Design Verification & Validation Review

Magnet Systems

Existing Inner PF Coils Issue & Gaps

NSTX-U Recovery Project

PF1B Bakeout Issue

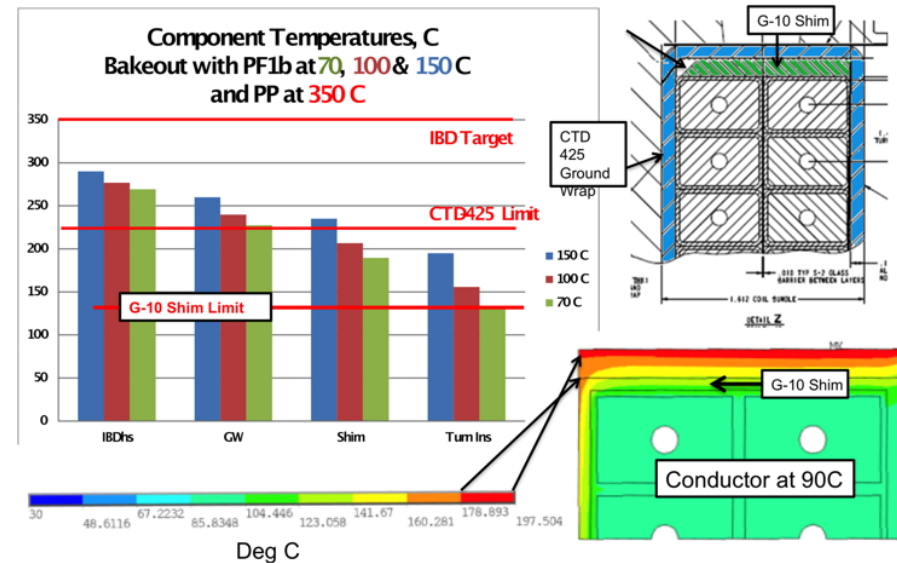
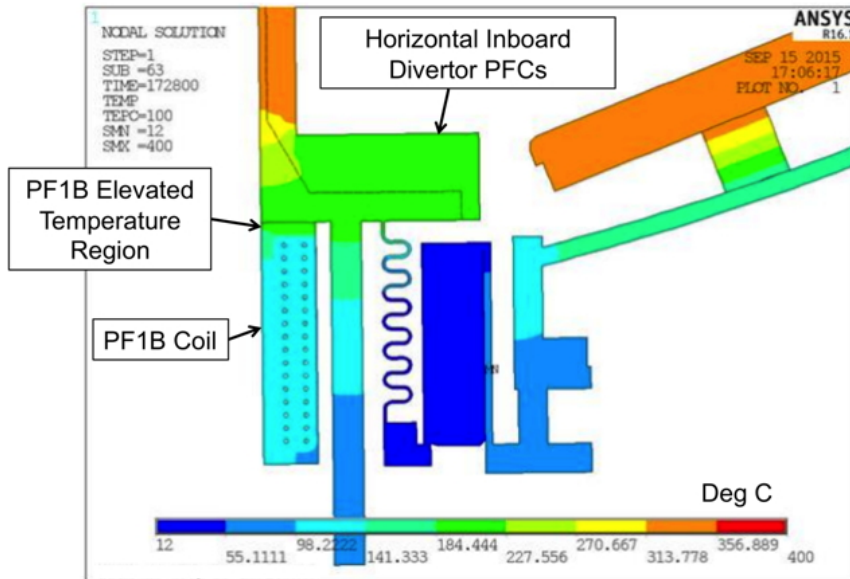
- Design issue related to ability to bake PFCs at 350°C vs. limit on PF1B temperature
 - Insulating materials exposed to relatively high temperatures

Insulation (1)

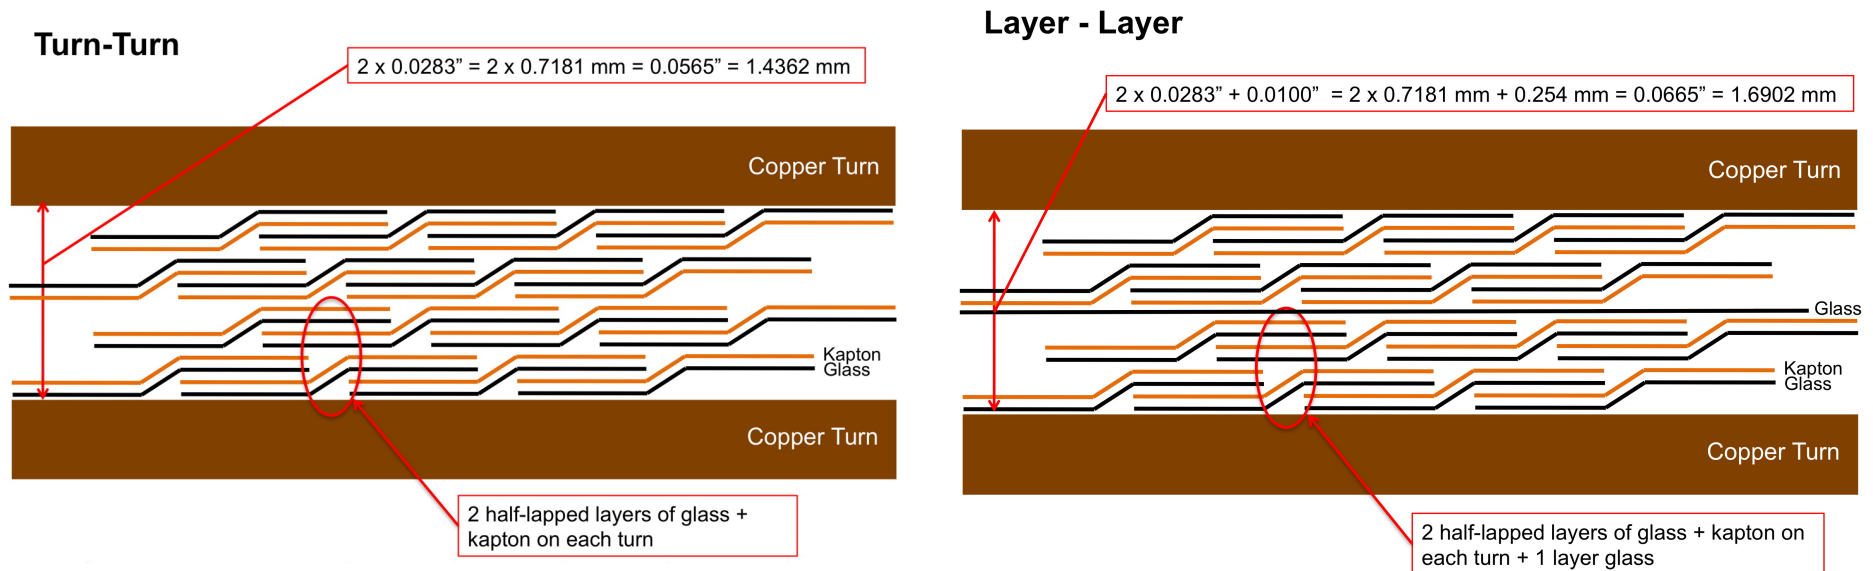
- Design point spreadsheet configuration
 - If glass facing conductor (favored for bonding insulation to conductor), then kapton-to-kapton interface exists midway between turns (undesirable)

Insulation (2)

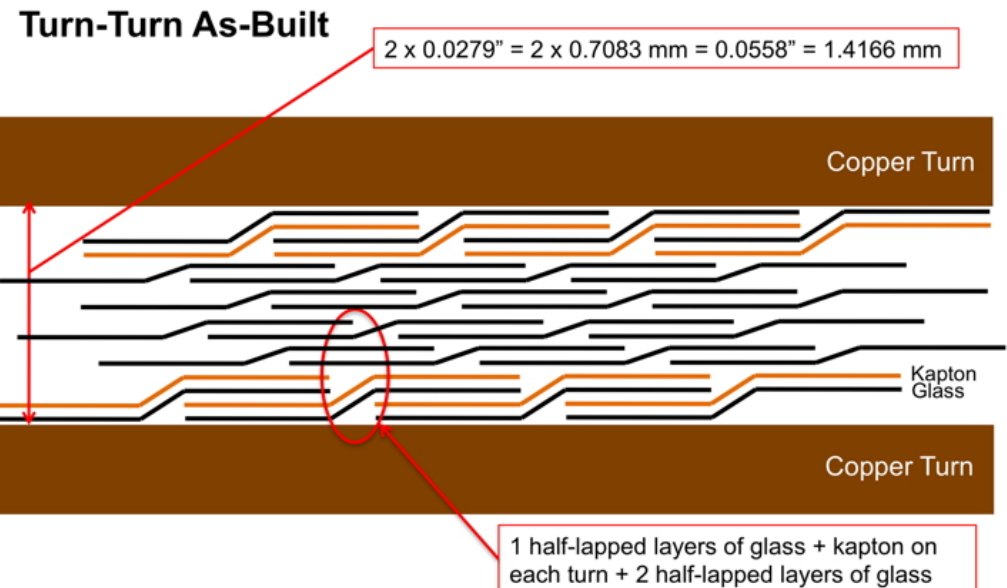
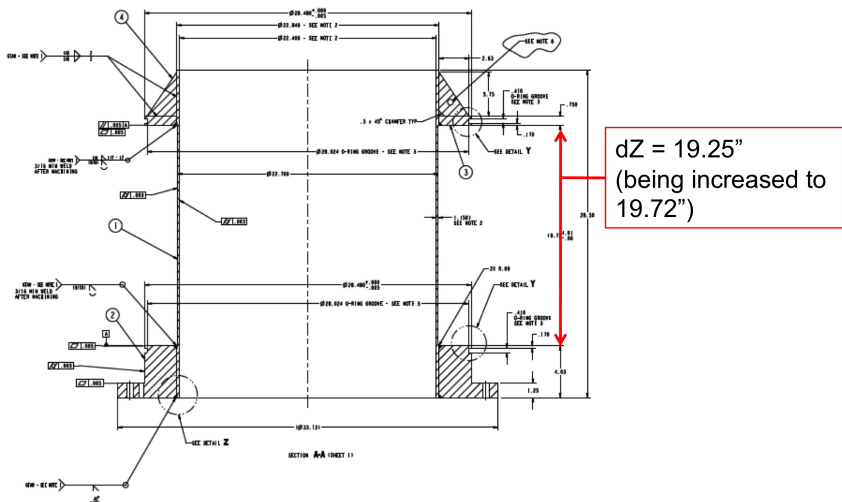
- To avoid kapton-to-kapton interfac (?) the spec called for the 2 co-wound layers of glass-kapton per the DPSS, then added 2 half-lapped layers of 0.004" glass.
 - would not fit in gap between the flanges on the mandrel
- One of the two layers of co-wound glass-kapton was eliminated

Vacuum Pressure Impregnation (2)

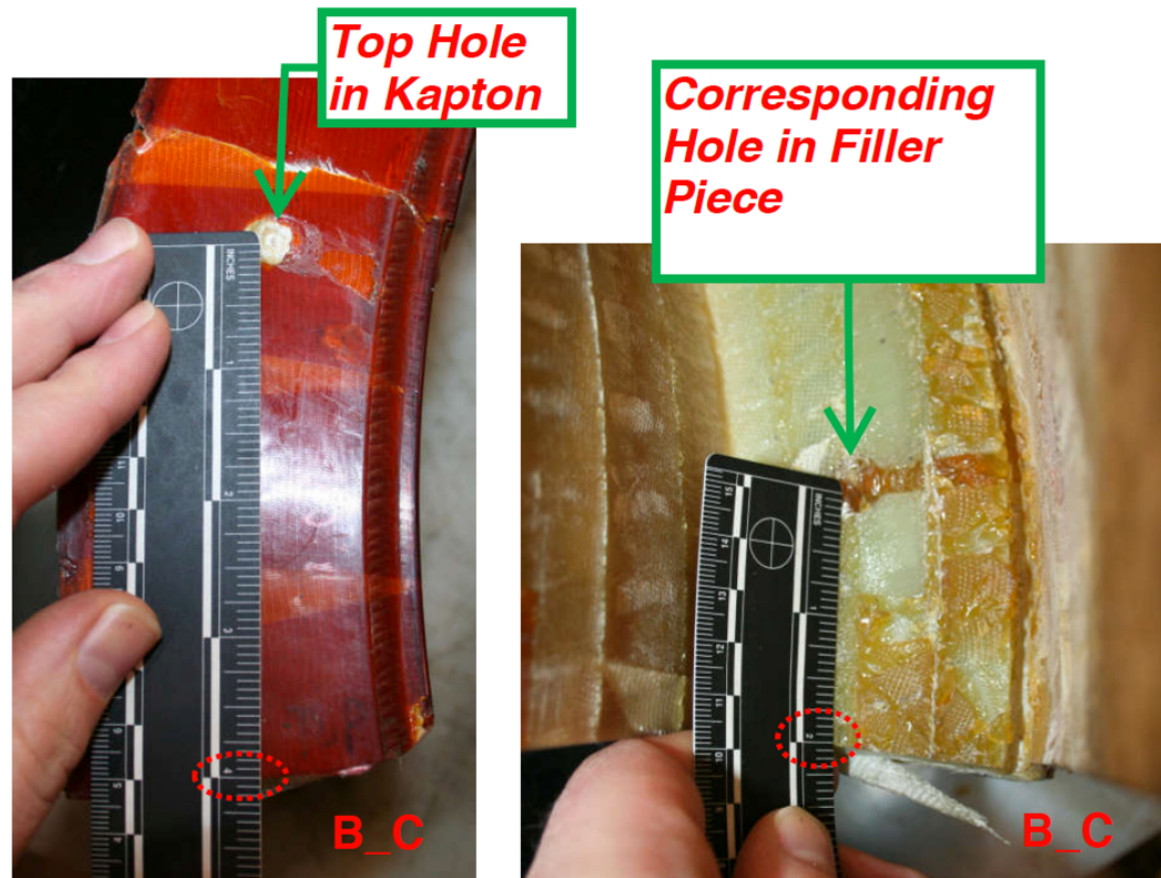
- Holes misaligned by 1.75" inches on PF1AU top flange, 0.625" on bottom flange

Vacuum Pressure Impregnation (3)

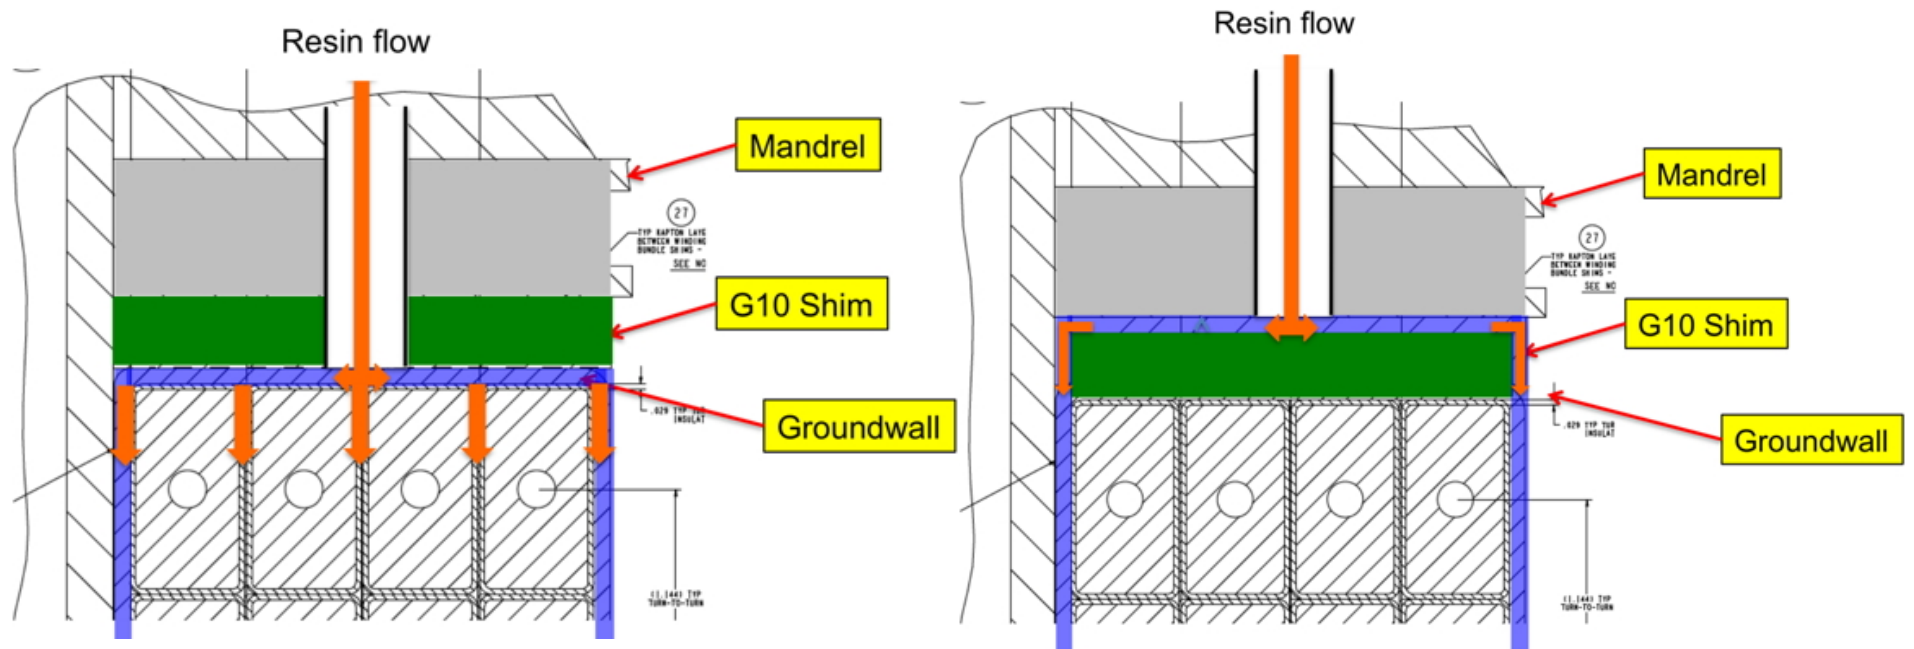
- Sprue hole misalignment increased impedance to resin flow but there was still a path

Specified arrangement of mandrel, G-10 shim and groundwall

As-built configuration and resin flow path

Ring Test - PF1AL v. U Pre-VPI

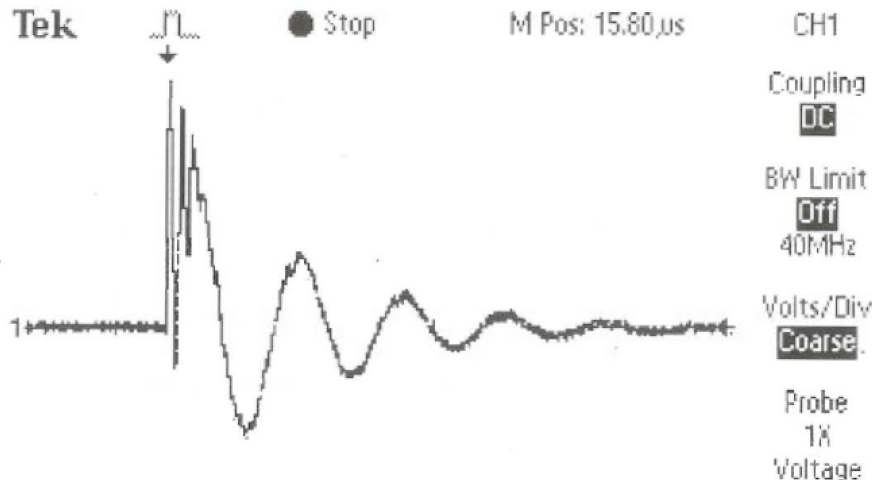
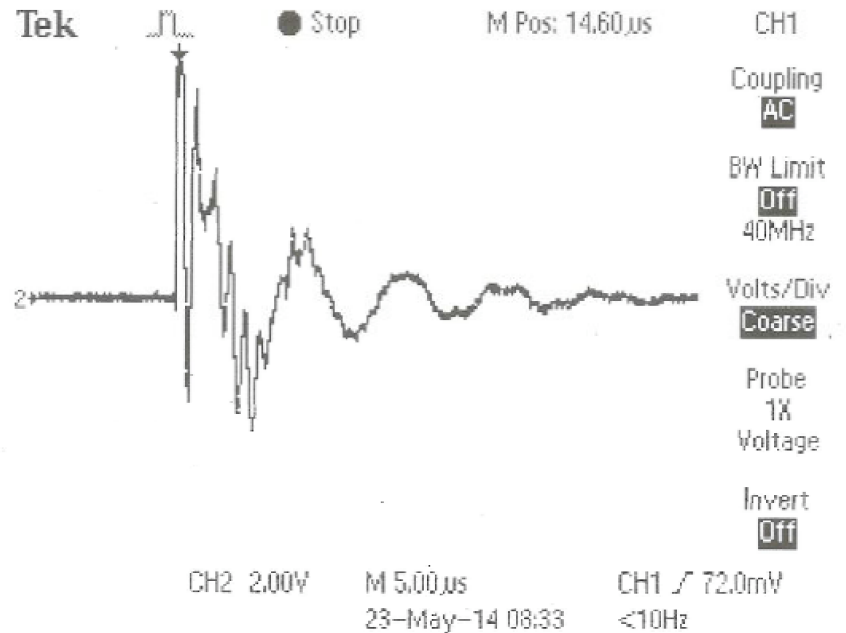
- The high frequency component increases from pre-VPI to post-VPI on PF1A-L but is similar on PF1A-U;
 - The pre-VPI high frequency component is more prominent on PF1A-U than PF1A-L;

Ring Test - PF1AL v. U Post-VPI

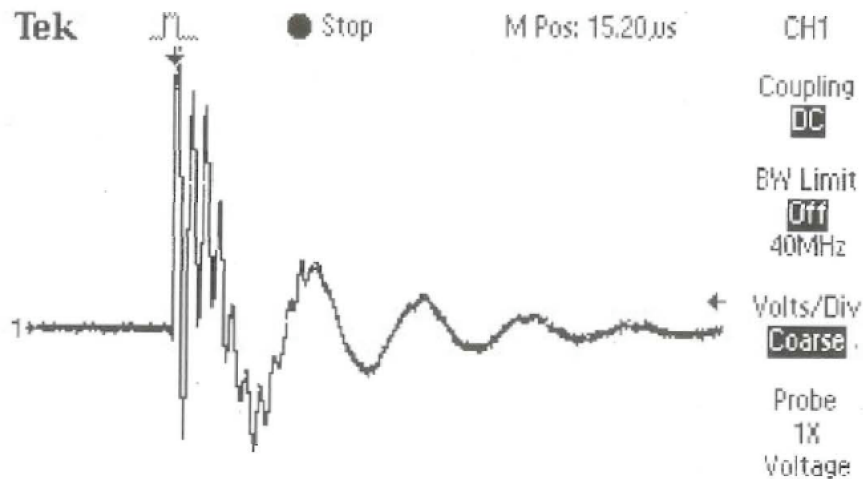
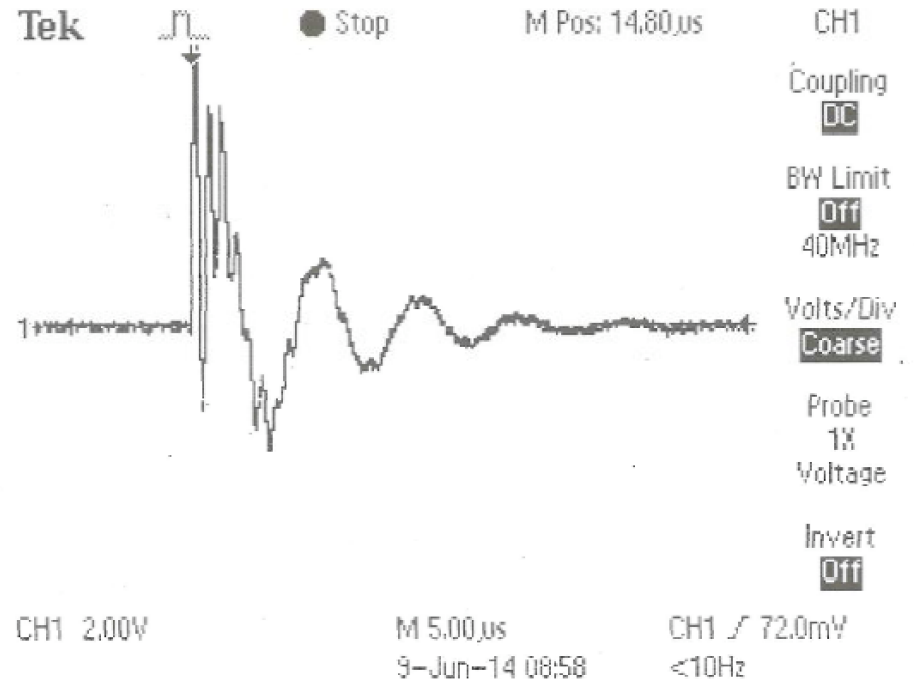
- The post-VPI waveforms are similar but not identical;
 - Ignoring the high frequency component, both coils exhibited the same basic oscillatory behavior;
